# STATE OF TEXAS DEPARTMENT OF TRANSPORTATION

## PLANS OF COMPLETED STATE HIGHWAY IMPROVEMENT

FEDERAL AID PROJECT BR 95(161), etc.

### "FINAL PLANS"

## TYPICAL CROSS SECTIONS

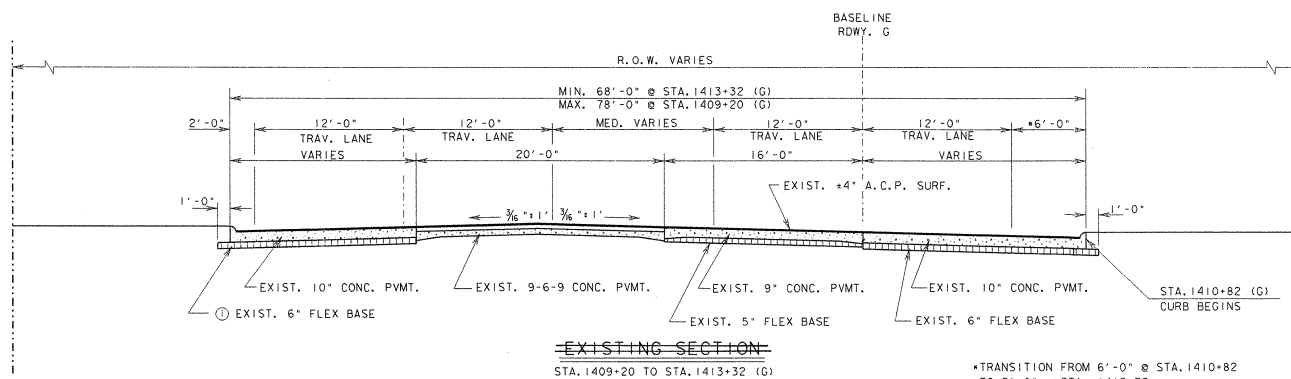
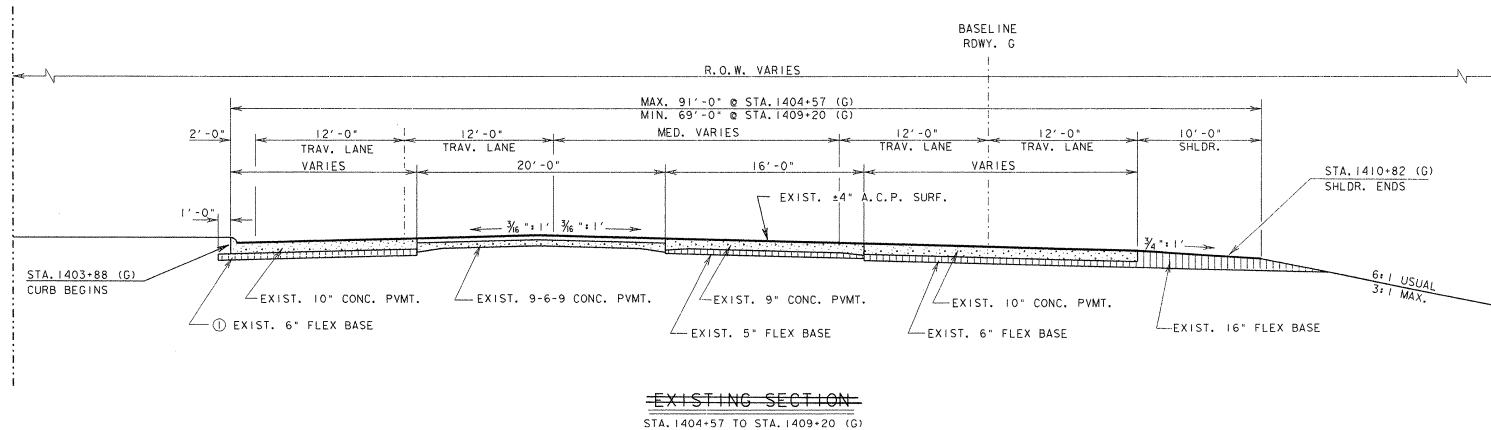
- ① ~~PROP.~~ REWORK BASE MATL. (TY. C)  
LIMITS SHOWN ON PLAN PROFILE SHEETS.
- \*\*② ~~PROP.~~ REWORK BASE MATL. (TY. B)  
LIMITS SHOWN ON PLAN PROFILE SHEETS.
- \*\*③ ~~PROP.~~ REWORK BASE MATL. (TY. B)  
FROM STA. 1191+60 TO STA. 1199+27.99 (G)  
THE REMAINING AREAS SHOWN ON THE  
PLAN PROFILE SHEETS WILL BE (TY. C).

SALV. FLEX BASE TO BE USED TO FILL  
\*\* IN MEDIAN & CONSTRUCT BOAT RAMP  
ACCESS ROAD.
